Newmar Corporation Warranty Department

Technical Service Bulletin							
Date Issued		Model Year(s) Affected		Model(s) Affected		TSB #	
10/19/2006		11/8/05 – 3/2/06		All Spartan Chassis		267	
Brand						Type	
All	<input checked="" type="checkbox"/>	American Star	<input type="checkbox"/>	Mountain Aire	<input type="checkbox"/>	All	<input type="checkbox"/>
		Dutch Star	<input type="checkbox"/>	Kountry Aire	<input type="checkbox"/>	F W	<input type="checkbox"/>
		Kountry Star	<input type="checkbox"/>	Essex	<input type="checkbox"/>	D P	<input checked="" type="checkbox"/>
Scottsdale	<input type="checkbox"/>	Northern Star	<input type="checkbox"/>	London Aire	<input type="checkbox"/>	D B	<input checked="" type="checkbox"/>
<div style="display: flex; justify-content: space-between;"> <div> <input type="checkbox"/> Air Conditioning & Heating <input type="checkbox"/> Appliances & Accessories <input type="checkbox"/> Cabinets & Furniture <input checked="" type="checkbox"/> Chassis Components <input type="checkbox"/> Construction Components </div> <div> <input checked="" type="checkbox"/> Electrical Components <input type="checkbox"/> Exterior Components <input type="checkbox"/> Interior Compon

3. Install the modified flue cap on the end of the flue tube (See Art01768):

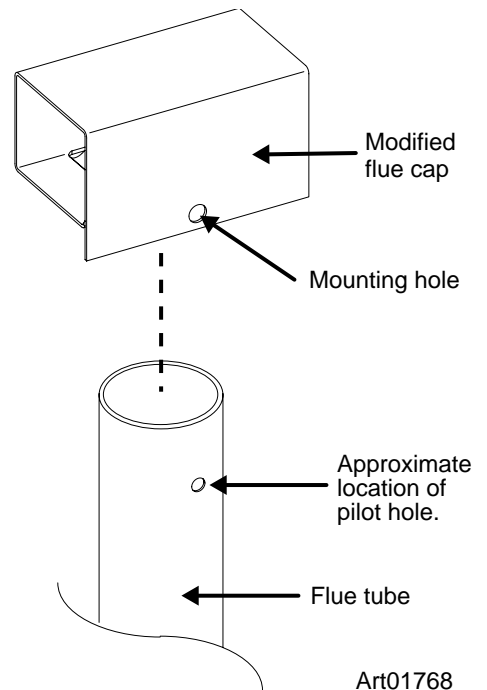
- Make sure the mounting hole of the modified flue cap is located away from the refrigerator cabinet back.
- Push the modified flue cap onto the end of the flue tube.

- Make sure that the long side of the modified flue cap is parallel with the refrigerator cabinet back.
 - At the center of the mounting hole, drill a .136 in. dia. (#29-bit) pilot hole through the flue tube.
 - Put the #8 self-drilling sheet-metal screw (supplied) through the mounting hole and into the pilot hole.
 - Securely tighten the screw.
4. Close the door of the upper side-wall exhaust vent.

INCORRECT INSTALLATION

The long edge of flue cap is NOT parallel with the refrigerator cabinet back.

CORRECT INSTALLATION

The long edge of flue cap IS parallel with the refrigerator cabinet back.
